Docket No. 52-021  
MHI Ref: UAP-HF-10016

**Subject:** Amended MHI's Responses to NRC's Requests for Additional Information on Advanced Accumulator for US-APWR Topical Report MUAP-07001-P, Revision 2

**Amended MHI's Responses to NRC's Requests  
for Additional Information**

**Advanced Accumulator for US-APWR Topical Report  
MUAP-07001-P, Revision 2**

Fig. 36-1 1/2 scale Model of Flow Damper with full-height Standpipe

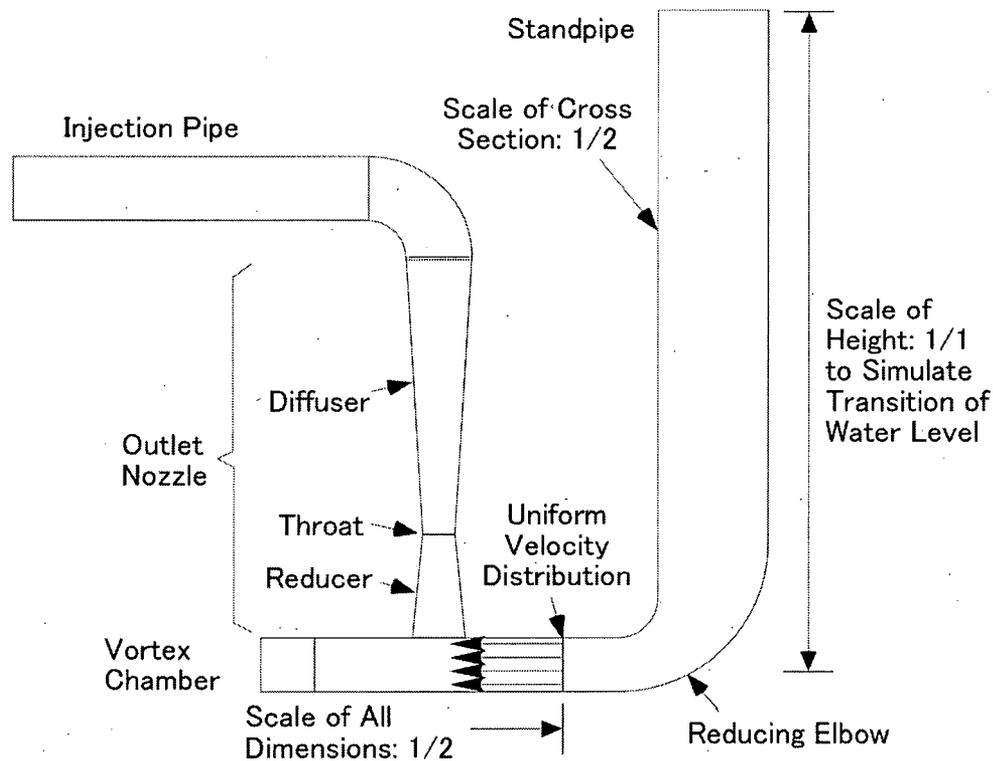
The accumulator characteristic correlations developed with the 1/2-scale accumulator test data indicate that the cavitation factor and flow rate coefficient are the only groups that represent important phenomena for high and low flow conditions.

(a) Are the cavitation factor and flow rate coefficient the only dimensionless groups that represent the important phenomena?

(b) In MHI's response to RAI 9-A (Sept, 2008), why is there no gravity term in the momentum equation? What are the boundary conditions (configuration)? What is the length scale (D) and the basis for being appropriate for all directions? Eq. 9-2 describes the local momentum balance. The statement below that Eq. states that the pressure loss is only function of Reynolds number. However, there is pressure loss beside the friction (viscous) loss that depends on the geometry. How is the pressure loss based on geometry preserved in different size facilities?

The states of flow in the full-height 1/2-scale model of the flow damper and the standpipe are shown in Fig. 36-1. The scale of all dimensions is 1/2 except the height of the standpipe. For large flow injection, the ratio of cross sectional areas of the standpipe and the large flow pipe is [ ] so that there is no flow separation in the elbow between them to make a uniform velocity distribution in the large flow pipe. (See "Handbook of Hydraulic Resistance," by I.E. Idelchik, pp.400-401, 4th Revised and Augmented Edition, Begell House, Inc., 2007) In other words, the length of the standpipe does not affect the flow in the flow damper. In addition to that, the inlet of the standpipe below the anti-vortex cap is designed to have configuration without flow separation so that flow in the standpipe is uniform. The ratio of cross sectional areas of the accumulator tank and the standpipe is [ ], so the flow toward the inlet of the standpipe is rapidly accelerated for which the accumulator tank serves as a reservoir where water is almost at rest. Consequently, flow at the inlet of the standpipe is not affected by the flow conditions in the accumulator tank but only by the gas pressure. Friction losses in the standpipe for both the actual accumulator and the full-height 1/2 scale model are less than [ ] of flow resistance of the flow damper and negligible. Friction loss in the flow damper was evaluated with the data of 1/5 and 1/2 scale models, and the scale effect to friction loss was confirmed to be negligible for the operating conditions of the advanced accumulator. It is because the length of the flow path in the flow damper is less than that of the standpipe in addition to high Reynolds number.

For flow switching, a water column in the standpipe is in one dimensional motion as in water hammer analysis. Since it has actual velocity, actual amount of undershoot of water level happens in the full-height 1/2-scale standpipe so that simulation of water level transition in the standpipe can be realized. This is the reason the full height standpipe was chosen for the 1/2 scale model.

flow switching. A water column in the standpipe is in one dimensional motion as in water hammer analysis, where the height of the standpipe affects the motion of the water column but the hydraulic diameter does not. Please see the Response to RAI 18, UAP-HF-08174-P(R0). Therefore, the height of the standpipe should be used for the Froude number. The height of the standpipe for the full height 1/2 scale model is the identical as for the actual one.

The minimum cross sectional area of the flow path is at the throat of the outlet nozzle. The cross sectional areas of the standpipe and the accumulator tank are [ ] and [ ] times the minimum cross sectional area respectively. Their dynamic pressures are less than [ ] of that at the throat and negligibly small. Consequently, the flow resistance of the advanced accumulator can be determined by the flow resistance of the flow damper.
